## TOWN OF EAGLE REFERRAL RESPONSE SUMMARY REPORT

ISSUED: April 15, 2024

Project Name: Red Mountain Ranch (RMR) Subdivision Sketch Plan – Parcels 1 & 2

Prepared by: Jessica Lake, Planner, Community Development Department

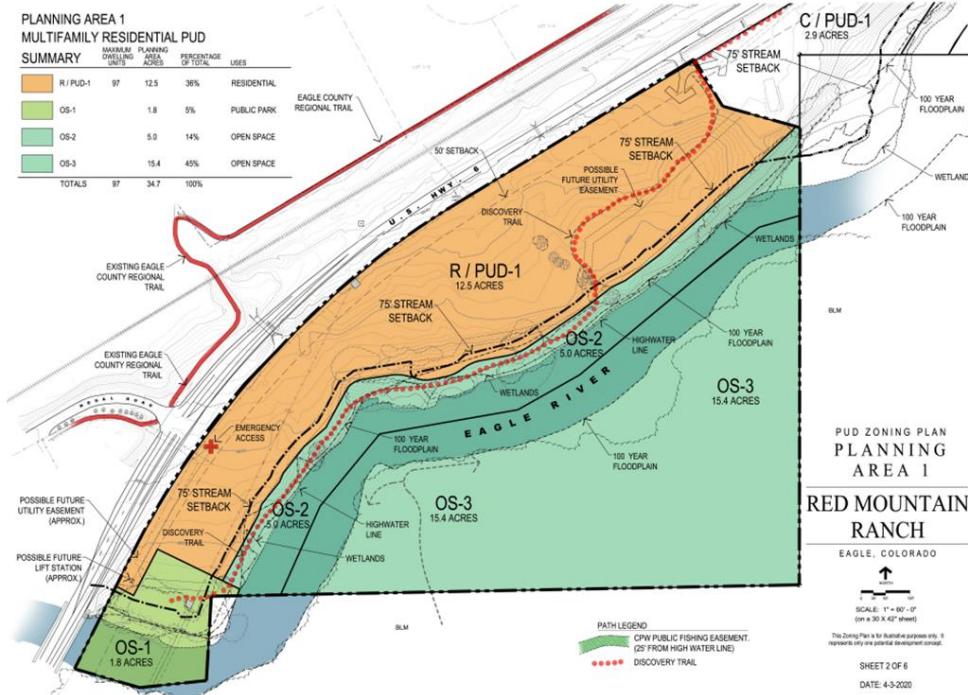
2. Sketch Subdivision Plan Set: Project Information: Zone Lot Information: OS-2 Lot Size should be 5 acres, not 17.5 acres. Please review all documents to ensure consistency with naming. PUD Guide and Zoning Plan show R/PUD-1, OS-1, OS-2, and OS-3 within Planning Area 1. Staff believes all OS's refer to Open Space tracts, please advise if this is not correct.

- A. **Noted, plans were referencing the Eagle Parcel Map which does not show OS-2 as a separate parcel. Future submissions will correctly list the different parcels and Open Space areas. All OS (Open Space) areas will remain as Open Space.**

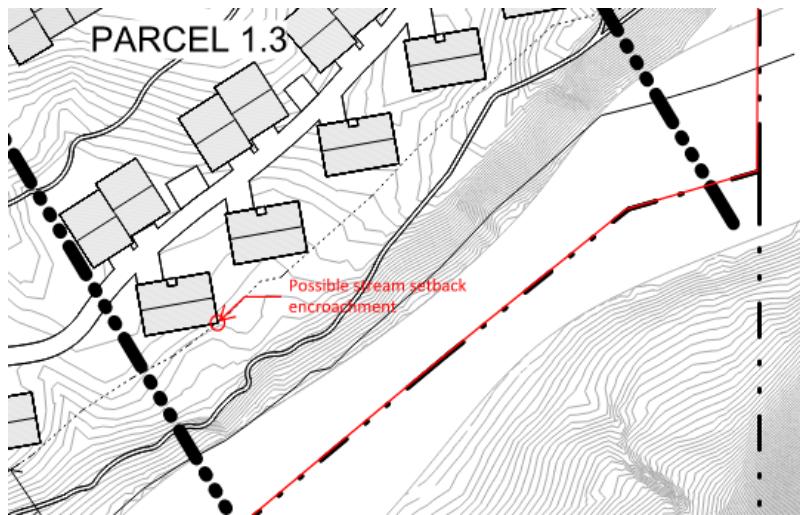
- 9. Planning Area 1 (R/PUD-1)
  - A. Setbacks Parcel 1: Most measurements were meeting or exceeding the requirement, however, it's pretty close in some areas. Staff recommends adding additional space, so that measurements are clearly exceeding the minimum requirements. Proposed structures do not encroach on the setbacks required along the river. With future applications, lots and structures will be clearly identified in regards to setbacks.

4) Confirm that the non-habitable surface parking areas, garages, etc. are not within the 25' minimum setback requirement from Hwy 6. Hwy 6 is not clearly designated on the site plan. Please confirm that all surface parking areas will be a minimum of 25' from Hwy 6.

1. **Along the 50' setback from Hwy 6, the first 25' does not contain any parking areas, garages, etc. Contained within the next 25' is, parallel parking designated for residential units, snow storage, and planting areas.**
